3. The NAS Prepublication Copy Misrepresents Casing Advance Drilling.

CCNS and Gilkeson: the NAS Prepublication Copy Misrepresents Casing Advance Drilling * July 12, 2007 * Attachment 3, page 10

Figure 3-1. Profiles of water chemistry in boreholes for LANL monitoring wells R-35a and R-35b. Source: LANL documents on file with NMED.

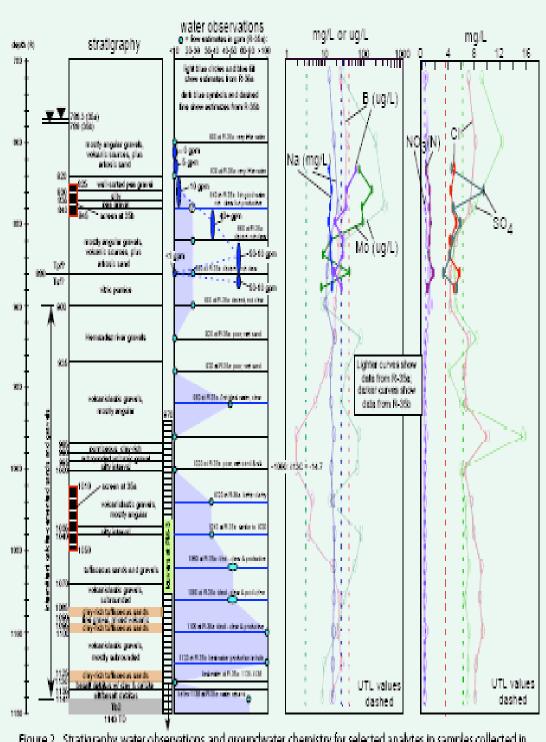
Furthermore, the ability of the air rotary reverse circulation drilling method to produce *in situ* samples of the formation water in real time during the drilling in perched zones of saturation and at discrete depths in the regional aquifer is another important advantage of using only air as a drilling fluid. The importance of collecting profiles of water chemistry in "real time" while drilling boreholes is illustrated by the recent success of this drilling method for the installation of the LANL monitoring wells R-35a and R-35b. The two new wells were installed to investigate the travel of the known plume of hexavalent chromium to the Los Alamos County drinking water well PM-3. Elevated levels of hexavalent chromium were not present in the water samples collected from the boreholes. However, elevated levels of molybdenum were present. The profiles of water chemistry are displayed in Figure 3-1.

At both well locations, drilling into the regional aquifer was with air rotary casing advance using only air as a drilling fluid. The reverse circulation drilling method allowed collection of *in situ* water samples in real time directly from the strata being drilled. Figure 3-1 presents the chemical profiles for select constituents in the borehole water samples. The profiles show high levels of molybdenum in discrete strata both near the water table and at depth across from the screened interval in the Los Alamos County drinking water well PM-3. Molybdenum was used to control corrosion in the TA-3 power plant cooling tower after the use of hexavalent chromium was stopped. A large volume of molybdenum-contaminated wastewater was discharged to Sandia Canyon.

The EPA does not have a drinking water standard for molybdenum. However, a 2004 EPA guidance recommends levels not to exceed 50 ug/L or 50 parts per billion (ppb) for molybdenum. Figure 3-1 shows that the levels of molybdenum measured in the strata near the water table are greater than 200 ug/L and the levels of molybdenum measured in the strata across from the well screen in drinking water well PM-3 are greater than 80 ug/L. The molybdenum analyses on the water samples produced from the two

boreholes were important information for the identification of the depth intervals to install the screens in wells R-35a and R-35b.
